**star bulletin**

Date: December 22, 2005
Order No.: P-B-15.30/55a
Supersedes: P-B-15.30/55 dated August 24, 2005
Group: 15

**SUBJECT: Model 203.040/052/054/056/061/064/065/076/081/084/087/092/261/264/281/284/740/747/764
All Model Years
Engine Not Starting / Starter Fuse Malfunctioning**

Figure 1

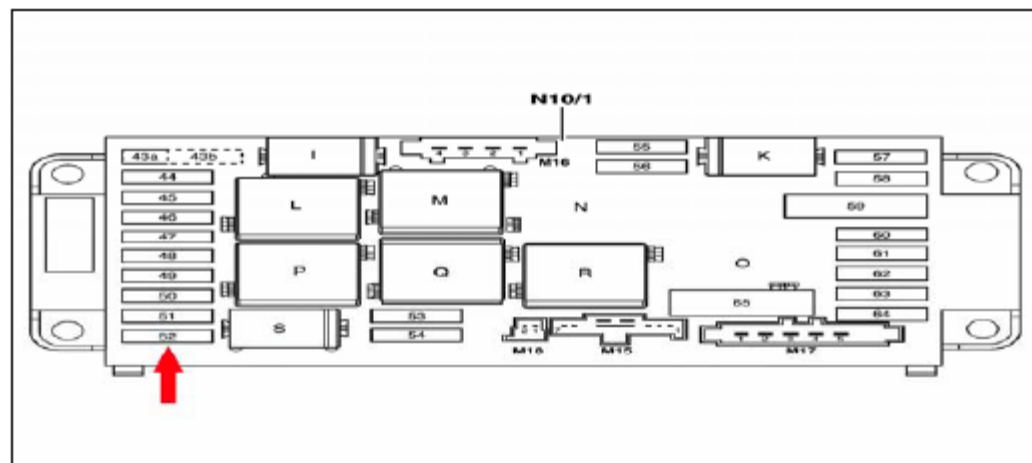
If you receive customer reports in the above model vehicles of the engine not starting, the Starter Fuse in the Driver Signal Acquisition and Actuation Module (SAM) may be malfunctioning. The Driver SAM should be fitted with a larger 20 Amp fuse.

1. Perform a visual inspection of the Driver SAM (N10/1) and determine which fuse is installed in socket 52 (Figure 1, arrow). Consult STAR Finder for more information on the location of this fuse (10/1f52).
2. Replace the currently installed 15 Amp fuse with the 20 Amp fuse specified in this DTB.
3. Record the fuse rating change on the vehicle's Fuse Chart.
